### PLAN COMMISSION MEETING AGENDA

### TUESDAY, February 9, 2016 AT 6:00 PM

**PROJECT:** Sign Plan Review – Steve Ignarski, Prairie Sign & Lighting (for MattressFirm)

**PROJECT:** Plan Review – Blair Williams, Wired Properties (on behalf of BelAir Cantina)

C43315-S1

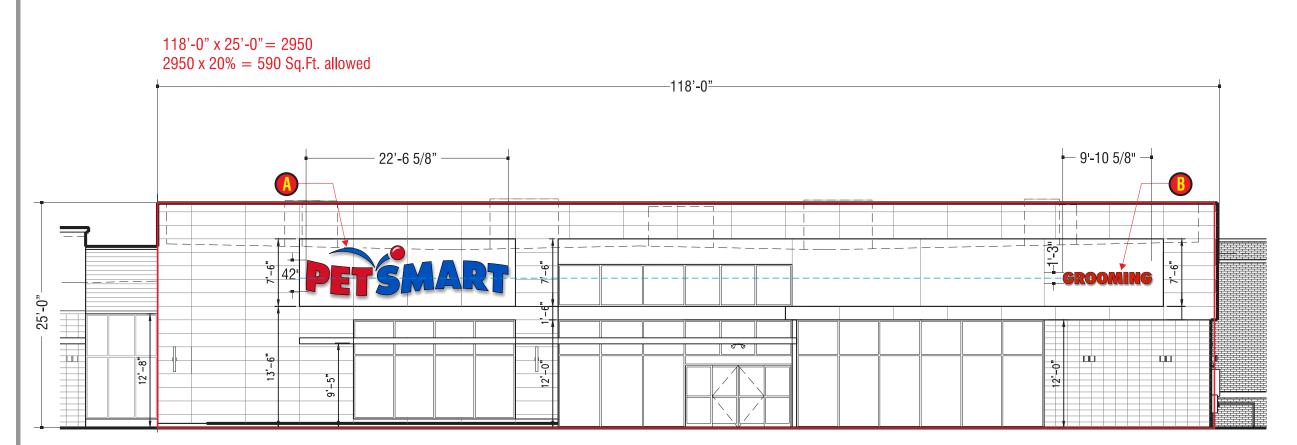
Commissioner Carrillo stated that she understands the applicant wants the signs without the swoosh and bigger lettering. Her concern is that when the swoosh is removed, it becomes really large in that area and it overpowers the PetSmart sign, which is smaller and contained within that square. Commissioner Carrillo stated that the sign is more appealing with the swoosh, even though it is adding a little color to the sign because it looks more balanced in that area. Mayor Scaffidi stated he concurred with Commissioner Carrillo.

Alderman Bukiewicz stated that the overall length without the swoosh is longer. Alderman Bukiewicz stated his personal preference that the sign with the swoosh looks better. If the applicant wants it gone, however, he is okay with that.

Commissioner Siepert stated he likes the sign without the swoosh. Ms. Papelbon noted that the applicant has pointed out that the sign on the east elevation is right-justified, rather than being centrally placed.

Mayor Scaffidi stated that the Plan Commission's direction to the applicant is that they want the swoosh incorporated into the signage.

- 1. That one (1) wall sign on the west elevation without the swoosh (maximum height of primary sign = 40 inches) and one (1) wall sign on the east elevation (maximum height of primary sign = 37.8 inches) in the locations shown on the plans approved April 28, 2015 are approved.
- 2. That one (1) internally-illuminated secondary monument sign (6'0" x 6'0") on the south portion of the property as shown on the plans approved April 28, 2015 that the sign is strictly in block letters with panels for both tenants is approved.

CONCEPT SITE PLAN
REVISED: FEBRUARY 2, 2016

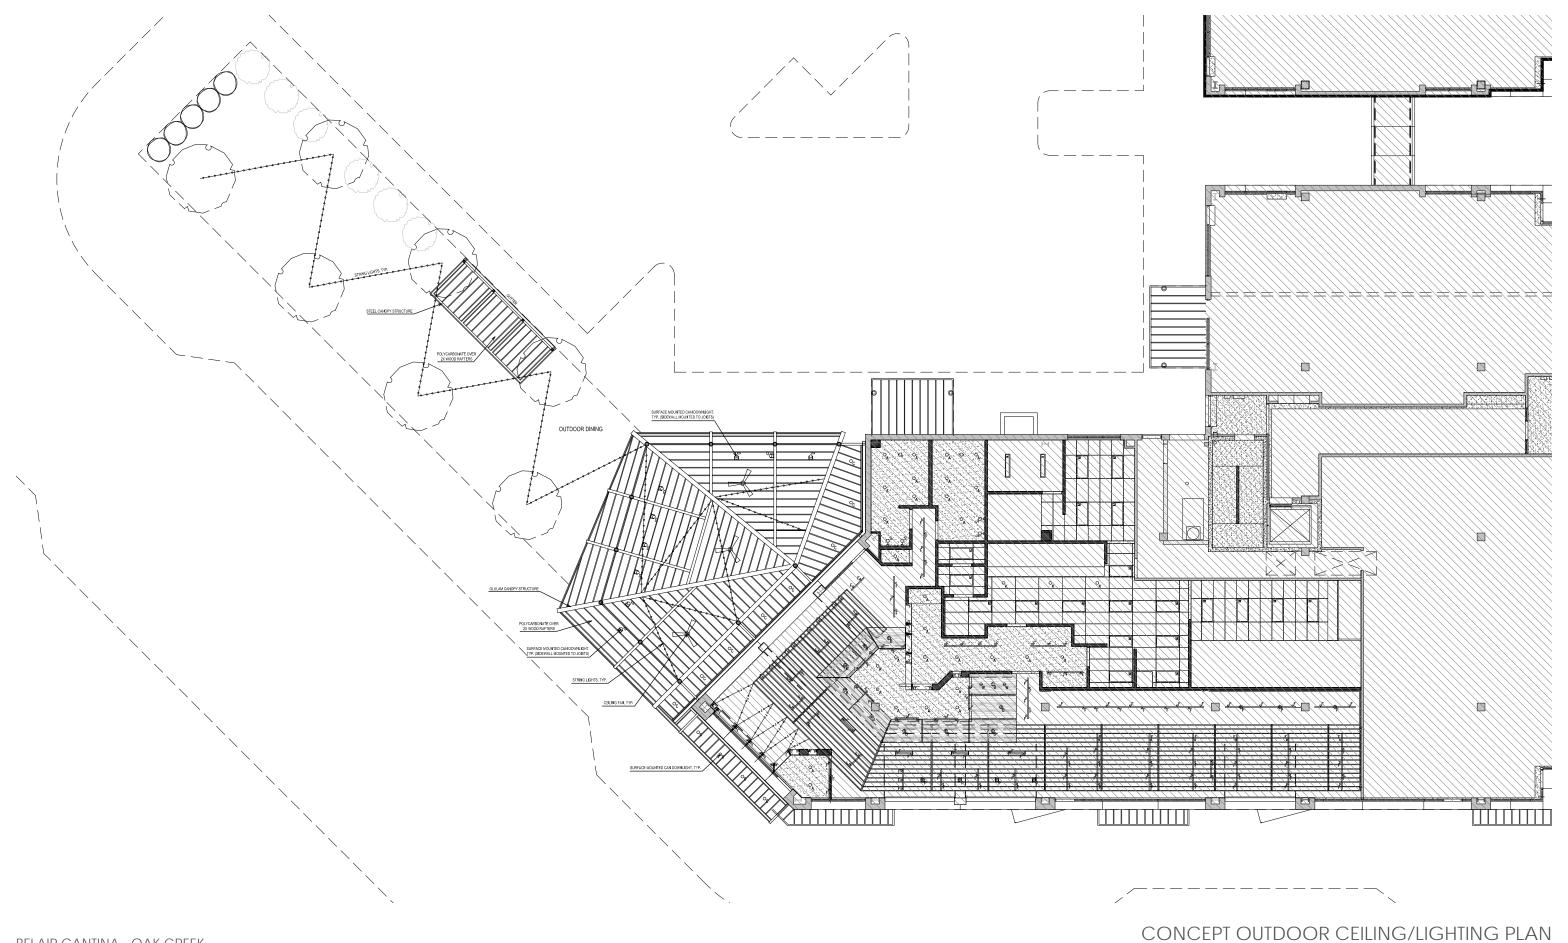
Plan Commissioners will note that the landscaping in the area, as well as the pedestrian walkway connection between the public sidewalk and the parking lot, have changed from the original approval (included in your packets). Landscaping was reduced to allow for the expansion of the outdoor dining area and to create a pocket park where the dining area ends. A revised, detailed landscape plan will be required to be submitted per the proposed condition of approval above. The pedestrian access was relocated from approximately the center of the outdoor area to the dining portion. Staff has concerns for the potential for this area to be restricted (dining podium, gate, etc.), and has proposed a condition that this access path remain open and unobstructed at all times.

Finally, there is a parking lot island directly across from the exterior dining area that had included landscaping in the original approved plans. Now the proposal shows pavers with no landscaping. Staff has concerns for the reduction in landscaping in the overall proposal, and recommends if this paver area is approved that it incorporates bicycle parking to complement the existing bicycle and pedestrian infrastructure.

- 1. That the pedestrian access path between the public sidewalk and parking lot remain open and unobstructed at all times.
- 2. That the proposed paver area immediately across from the outdoor dining area incorporates bicycle parking.
